National Electrical Safety Code

Interpretations

1984 — 1987 inclusive

National Electrical Safety Code Interpretations

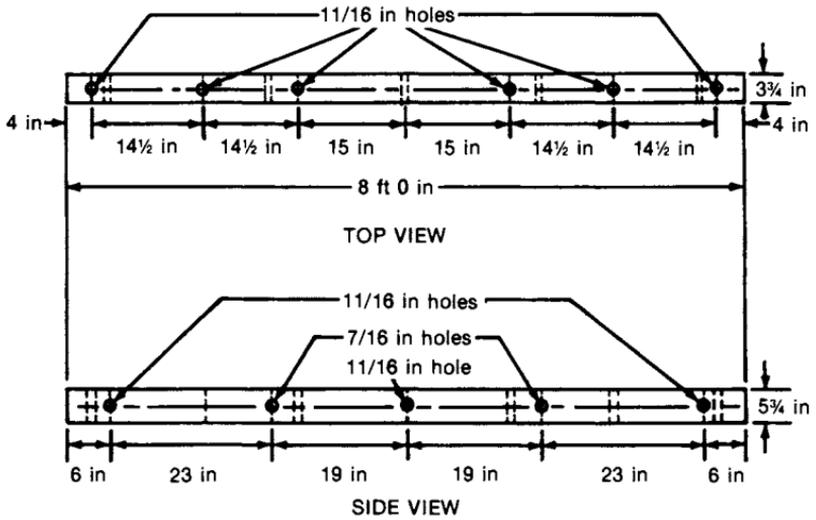
First, in Table 261-6, "Minimum Dimensions of Crossarm Cross Section," we question what is meant by "Number of Pins." If we use an 8 ft crossarm that carries three conductors (or pins), in which category does our arm fall? Although we refer to this as a six-pin arm, no more than three pins (or conductors) are carried by the arm at one time (see Fig IR 376).

Second, in Rule 261D, "Crossarms," we question the safety factor, if any, that should be applied on crossarms for dead-ends. It is stated clearly that the vertical loads (Rule 261D1) shall not exceed 50% of the ultimate strength of the wood, yielding a safety factor of 2.0. However, when examining the longitudinal strength requirement (Rule 261D3), which we are presently interpreting to include dead-ends, a safety factor is not evident. If Rule 261D3b applies, would a crossarm section larger than that shown in Table 261-6 be able to carry a proportionally greater conductor tension (over 2000 lb)?

Stresses resulting from conductor tensions computed at 700 lb, as per Rule 261D3, provide small factors of safety that vary according to the grade of the crossarm, dimensions, and allowable fiber stress. Accordingly, the 700 lb loading or its equivalent results in a stress that approaches, but does not exceed, an overload capacity factor of unity. No overload capacity factor is stated as such when the expected loading is greater than 700 lb; Rule 261D3 implies a required overload capacity factor of unity where conductor tension is greater than 700 lb. This rule applies both to dead end and line poles; the code requires the designer to assure that the conductor loading on the crossarms will not exceed its designated fiber stress (or ultimate strength). Note that conductor tension resulting from all sources, including wind and ice loading, must be included. Rule 261D3a requires that, at a minimum, the crossarm be able to hold the forces capable of being withstood by good wood pins—700 lb.

Fig IR 397

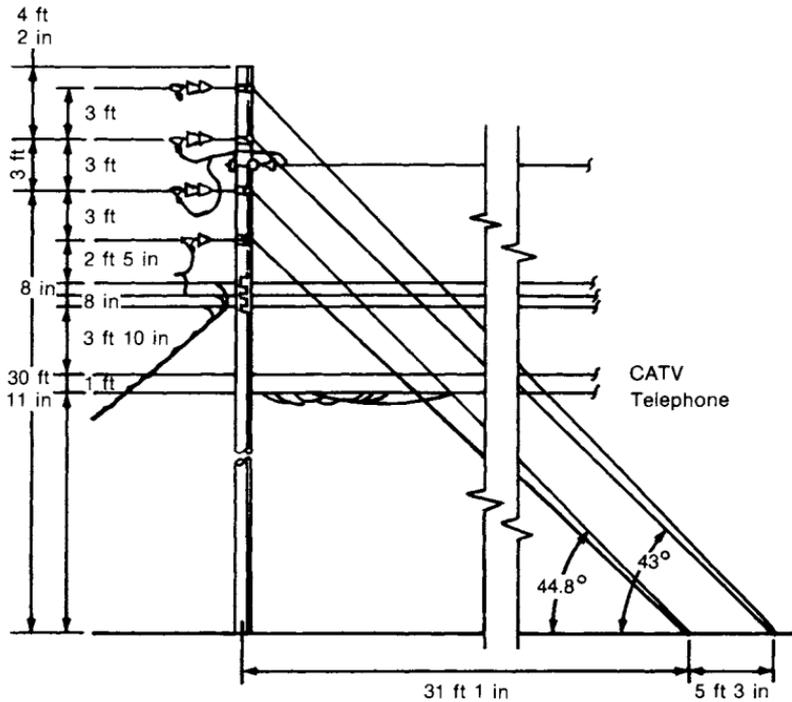
Please provide your interpretation of "readily climbable" as referenced in Rule 280A1b of the 1984 Edition of the National Electrical Safety Code.

In conjunction with the above interpretation, Fig IR 397 is a drawing showing our standard construction practice for a guyed dead end pole. Are these or similar structures considered to be "readily climbable" by unauthorized persons?

The definition of readily climbable as defined in the 1987 Edition of the NESC is "having sufficient handholds and footholds to permit an average person to climb easily without using a ladder or other special equipment." The deadend pole in question has neither handholds nor footholds. However, please reference the guy locations and interpret whether the guying for this structure is considered to be "readily climbable" by unauthorized personnel. The guy strand could be either 5/16 in or 7/16 in wire.
